Attorney Docket No.: 46440-0009017

Presented for filing is a new continuation patent application for prioritized examination of:

Title: BI-DIRECTIONAL FIXATING TRANSVERTEBRAL BODY SCREWS AND POSTERIOR CERVICAL AND LUMBAR INTERARTICULATING JOINT CALIBRATED STAPLING DEVICES FOR SPINAL FUSION

Fig. 4

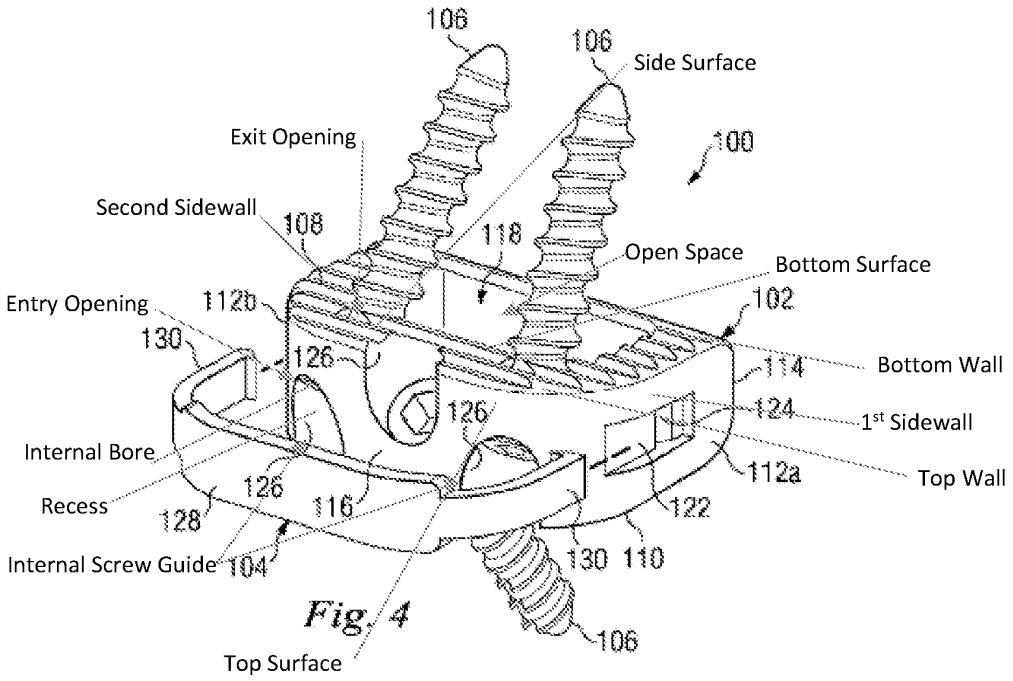
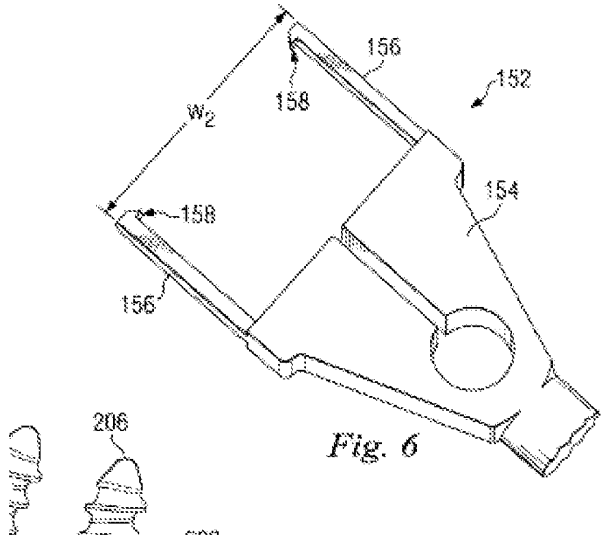
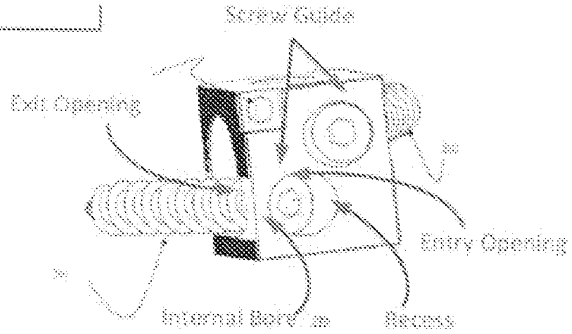
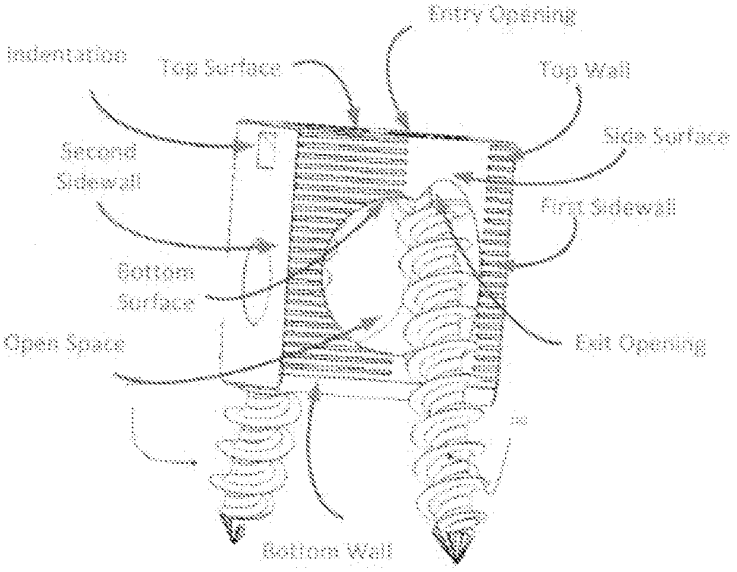
Concerning claim 21, **as best understood with support from the annotated document (see below) submitted by Applicant during a telephone interview with the examiner**, Waugh et al. disclose an intervertebral implant (see Fig. 4 below) comprising: a top wall including a top surface and a bottom surface opposite the top surface; a bottom wall opposite the top wall; a first sidewall; a second sidewall opposite the first sidewall, wherein the top wall, bottom wall, first sidewall and second sidewall define an open space capable of receiving bone filling for biological bone fusion; and an internal screw guide having an internal bore and a recess extending into the top surface of the top wall, the internal bore having an entry opening and an exit opening, the entry opening of the internal bore formed at a juncture between the internal bore and the recess, the entry opening of the internal bore formed only in the top surface of the top wall, the recess sized and shaped to accommodate a screw head, and the exit opening formed at least partially in the bottom surface of the top wall and at least partially in a side surface of the top wall.

Concerning claim 29, the intervertebral implant including a first indentation on the first sidewall of the intervertebral implant and a second indentation on the second sidewall of the intervertebral implant (see Fig. 4, elements 122 and 124).

Concerning claim 30, wherein the internal screw guide is a first internal screw guide, and the intervertebral implant further comprises: at least a second internal screw guide having a second internal bore with a second entry opening and a second exit opening, the second entry opening formed within a second recess formed in the top wall and extending into the top surface of the top wall and oriented in a different direction than the internal bore of the first internal screw guide (see Fig. 4 above).

Concerning claim 36, wherein the first internal screw guide has a first angle with respect to the top wall of the intervertebral implant and the second internal screw guide has a second angle with respect to the top wall of the intervertebral implant, and wherein the first angle and the second angle extend through opposite sides of the intervertebral implant (see Fig. 4, left screw and middle screw).

Fig. 2C

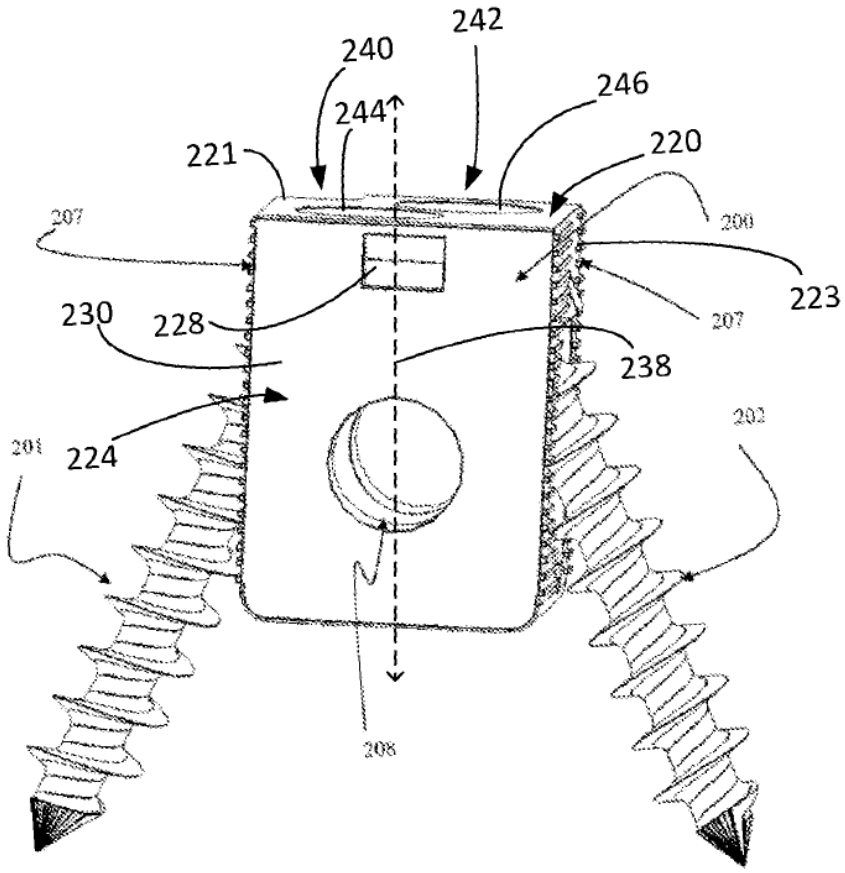
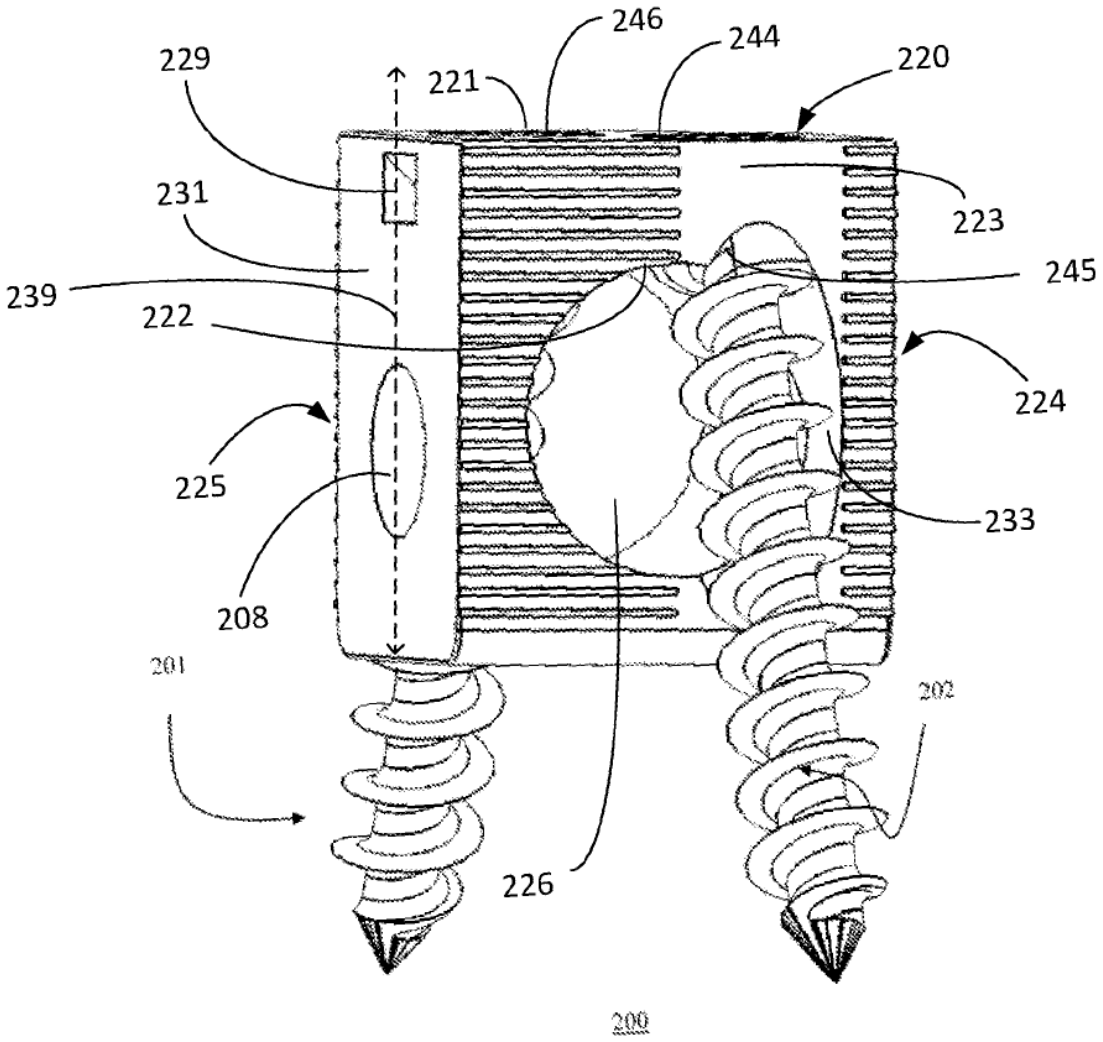
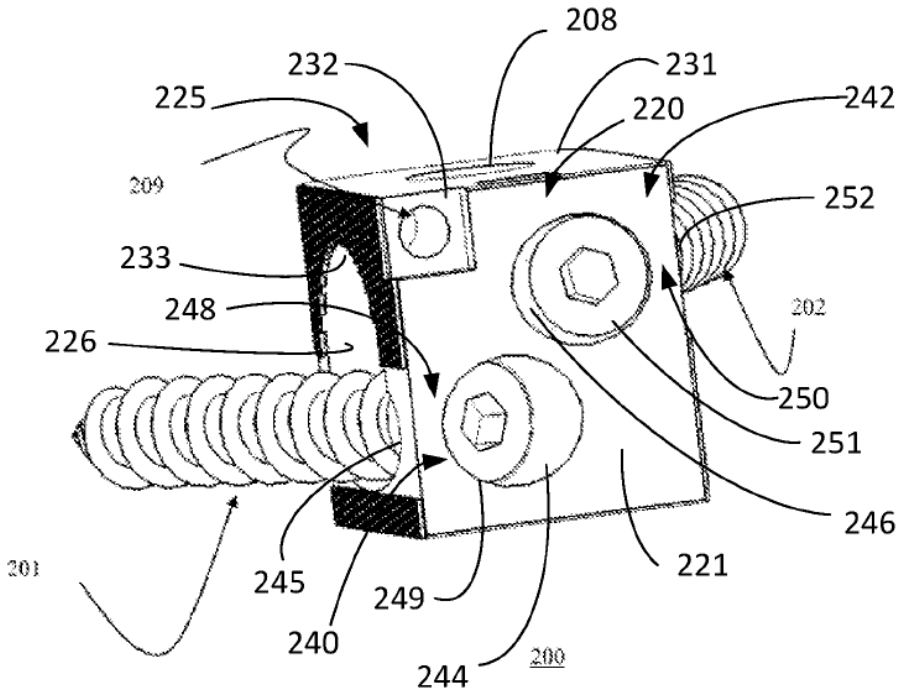
The drawings are objected to under 37 CFR 1.83(a). The drawings must show every feature of the invention specified in the claims. Therefore, regarding claims 21-32 and 41-44, the top wall; top surface; bottom surface; bottom wall; first sidewall; second sidewall; open space; internal screw guide; internal bore; recess; entry opening; exit opening; first indentation; second indentation; second internal screw guide; second internal bore; second entry opening; second exit opening; second recess; threaded hole; rectangular indentation; first slot; first outer surface; second slot; second outer surface; and first and second centerline axis must be shown or the feature(s) canceled from the claim(s). Regarding claims 33-36, the top wall; top surface; bottom surface; bottom wall; first sidewall; second sidewall; internal screw guide; internal bore; entry opening; exit opening; side surface; first indentation; first surface; second indentation; second surface; second internal screw guide; and second internal bore must be shown or the feature(s) canceled from the claim(s). No new matter should be entered.

As stated in the Final OA the examiner noted that reference numbers 248, 240, 242, 250 in amended Fig . 2C do not point to relevant structure. Additionally, the drawings fail to illustrate an entry opening of the internal bore that is formed only in the top surface of the top wall AND formed at a juncture between the internal bore and the recess. The drawings fail to show any structural difference between the internal bore and the internal screw guide.

The attached replacement sheets of drawings (3) includes changes to Figs. 2A-2C and replace the original sheets including Figs. 2A-2C.

In Figures 2A-2C, reference numerals and lead lines are added to correspond to the reference numerals associated with the structures recited in the claims in new paragraph [0064.1].

The drawings were objected to as failing to show each and every feature of the invention specified in the claims. Applicant has amended Figs. 2A, 2B, and 2C to include reference numerals and lead lines corresponding to the claimed structure, which is further described in new paragraph [0064.1] of the amended specification. The replacement sheets (3) including Figs. 2A-2C are submitted herewith. No new matter is added by the amendment to the drawings.

Fig. 12

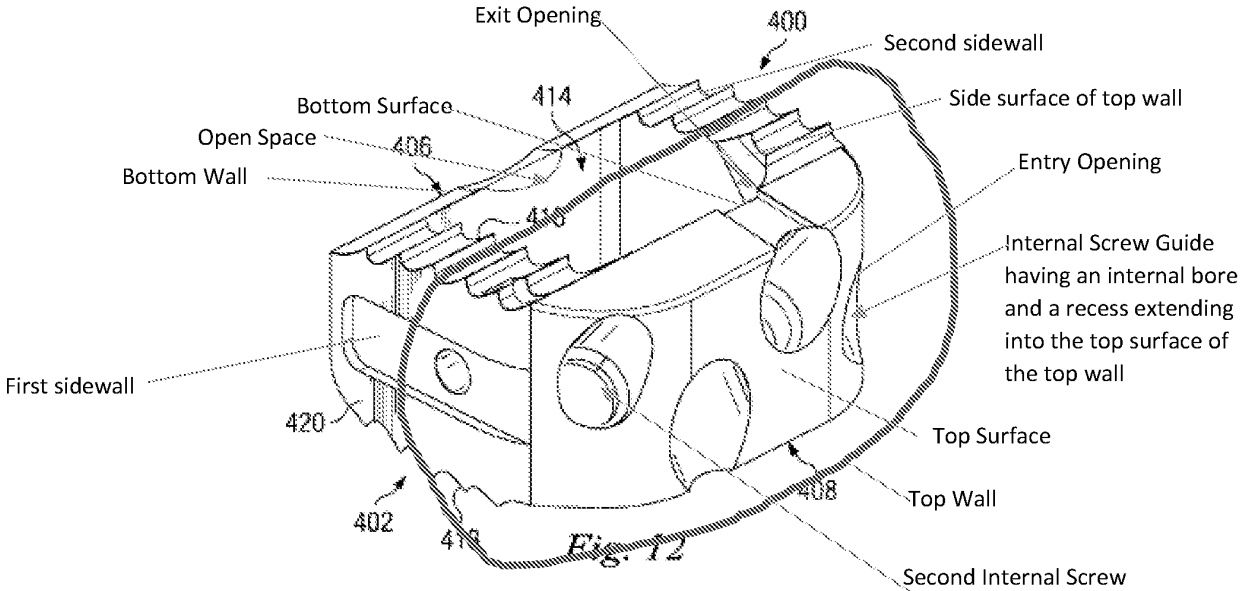
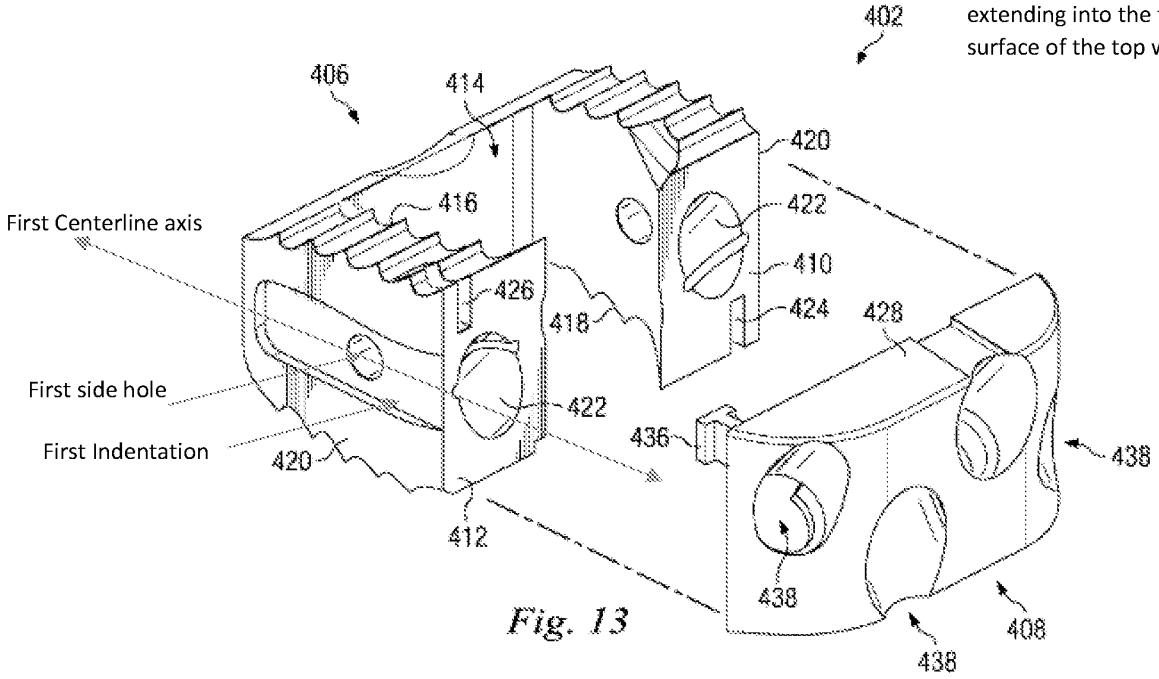
Concerning claim 21, as best understood, Waugh et al. disclose an intervertebral implant comprising: a top wall (see Fig. 12 below) including a top surface (see Fig. 12 below) and a bottom surface (see Fig. 12 below) opposite the top surface; a bottom wall (see Fig. 12 below) opposite the top wall; a first sidewall (see Fig. 12 below); a second sidewall (see Fig. 12 below) opposite the first sidewall, wherein the top wall, bottom wall, first sidewall and second sidewall define an open space (see Fig. 12 below) capable of receiving bone filling for biological bone fusion; and an internal screw guide (see Fig. 12 below) having an internal bore and a recess extending into the top surface of the top wall, the internal bore having an entry opening (see Fig. 12 below) and an exit opening (see Fig. 12 below), the entry opening of the internal bore formed at a juncture between the internal bore and the recess, the entry opening of the internal bore formed only in the top surface of the top wall (see Fig. 12 below), the recess sized and shaped to accommodate a screw head of a screw, and the exit opening formed at least partially in the bottom surface of the top wall and at least partially in a side surface (see Fig. 12 below) of the top wall; wherein the intervertebral implant does not include a faceplate to retain the screw in the internal screw guide.

Concerning claim 25, wherein each of the first sidewall and the second sidewall has a surface positioned opposite to a first surface configured to contact one of the first vertebral body and a second surface of the second vertebral body when the intervertebral implant is inserted into the disc space (see Fig. 12).

Concerning claim 30, wherein the internal screw guide is a first internal screw guide, and the intervertebral implant further comprises: at least a second internal screw guide (see Fig. 12 above) having a second internal bore with a second entry opening and a second exit opening, the second entry opening formed within a second recess formed in the top wall and extending into the top surface of the top wall and oriented in a different direction than the internal bore of the first internal screw guide.

Fig. 12

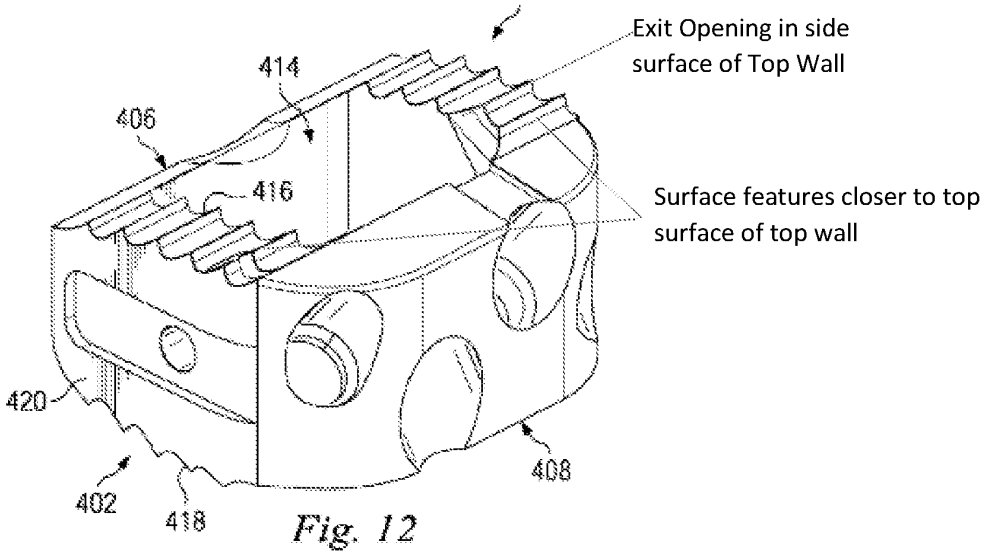
Concerning claim 42, wherein at least some of the plurality of surface features (see Fig. 12 below) are positioned on the side surface of the top wall closer to the top surface of the top wall than the exit opening.

Concerning claim 43, wherein the plurality of surface features are ridges (see Fig. 12 above) extending from the side surface of the top wall and the side surface of the bottom wall, the ridges positioned around the open space capable of receiving bone filling for biological bone fusion.

Fig. 12

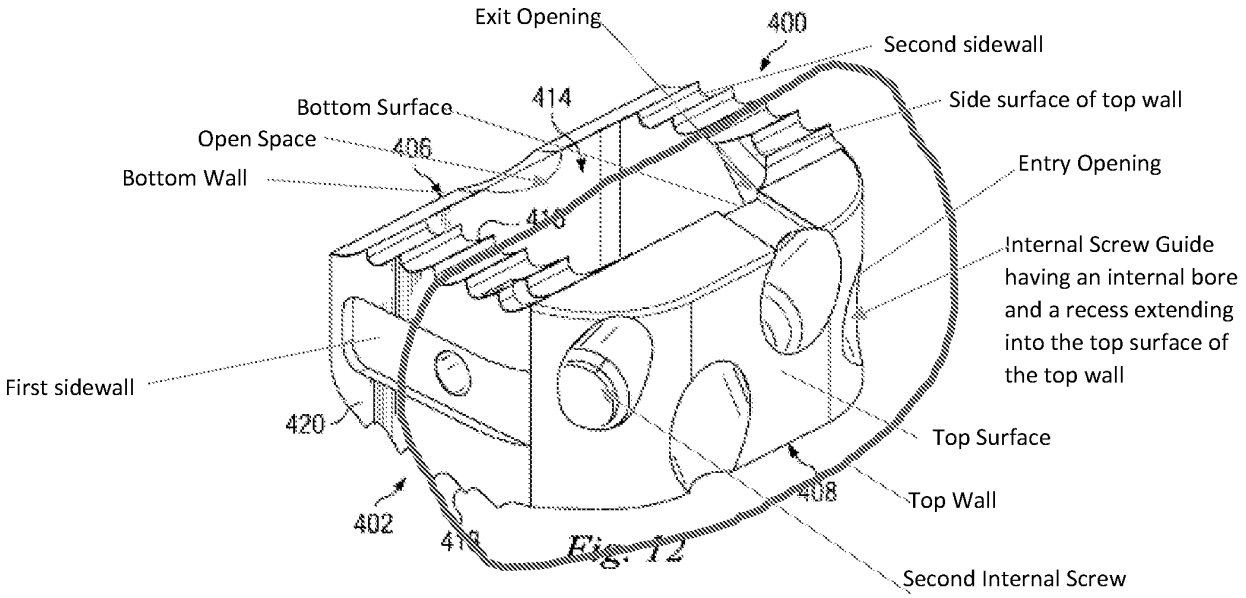
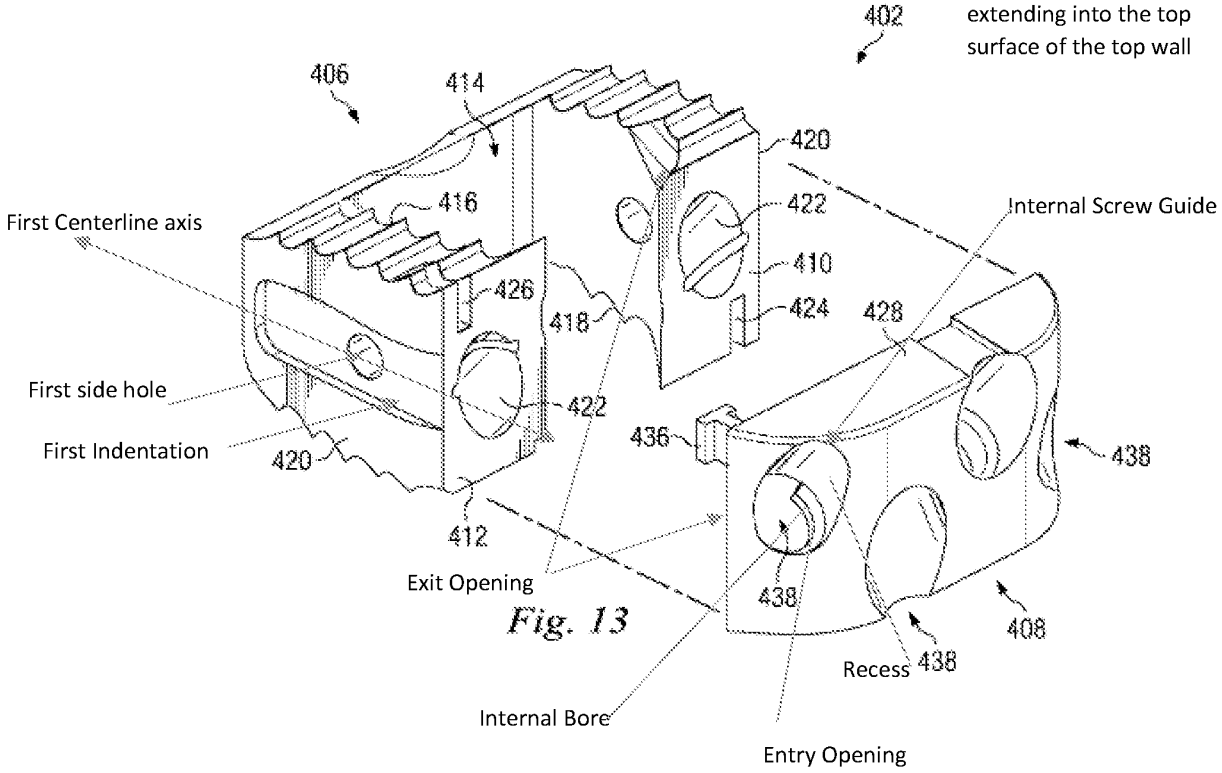
Concerning claim 45-47, Waugh et al. disclose an intervertebral implant system comprising: a top wall (see Fig. 12 above) including a top surface (see Fig. 12 above) and a bottom surface (see Fig. 12 above) opposite the top surface; a bottom wall (see Fig. 12 above) opposite the top wall; a first sidewall (see Fig. 12 above); a second sidewall (see Fig. 12 above) opposite the first sidewall, wherein the top wall, bottom wall, first sidewall and second sidewall define an open space (see Fig. 12 above) capable of receiving bone filling for biological bone fusion; and an internal screw guide (see Fig. 12 above) having an internal bore (see Fig. 13 above) and a recess (see Fig. 13 above) extending into the top surface of the top wall, the internal bore having an entry opening (see Fig. 12 above) and an exit opening (see Fig. 12 above), the entry opening of the internal bore formed at a juncture between the internal bore and the recess, the entry opening of the internal bore formed only in the top surface of the top wall, the recess

Concerning claim 48, wherein the intervertebral implant system does not include a faceplate to retain the screw head in the internal screw guide (see Fig. 12).
